Proposal for addition of lateral  
facing carrycot icon to the module  
labelling options.

Erik Salters,  
Dorel  
18 oktober 2016

# Current R129-01

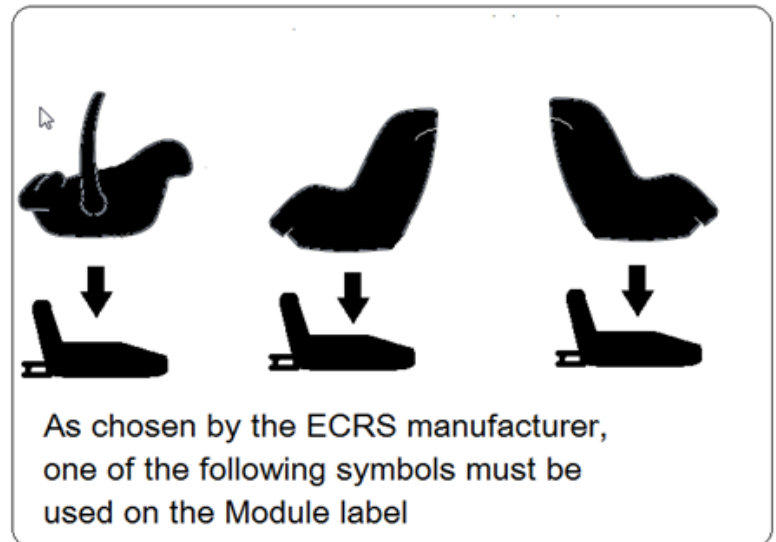
- Current R129-01 depicts following label to be placed on a module

- This module label must use one of the following symbols:

# Lateral Facing Carrycots & Combination seats

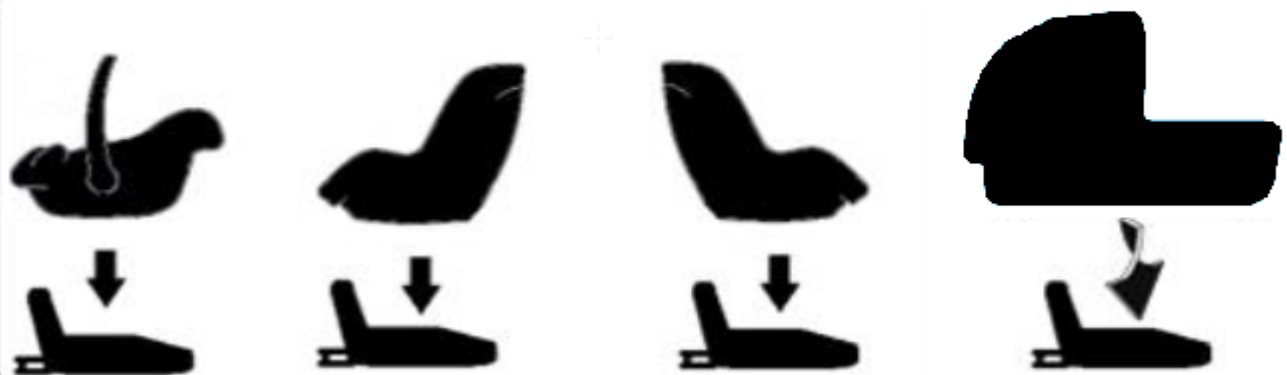
- Lateral Facing carrycots could also be installed on an ISOFIX base
  - ❑ Propose to depict a symbol showing a LF carrycot
- Seats exist that combine a rearward and forward facing mode. It could lead to misunderstanding if only one of these modes is depicted on the module label (regardless of the question which one should be chosen? )
  - ❑ Propose to allow more than one symbol on the module label

Proposal  
old:

As chosen by the ECRS manufacturer,  
one of the following symbols must be  
used on the Module label

new:

By choice of the ECRS manufacturer, one or more of the  
following symbols must be used on the module label
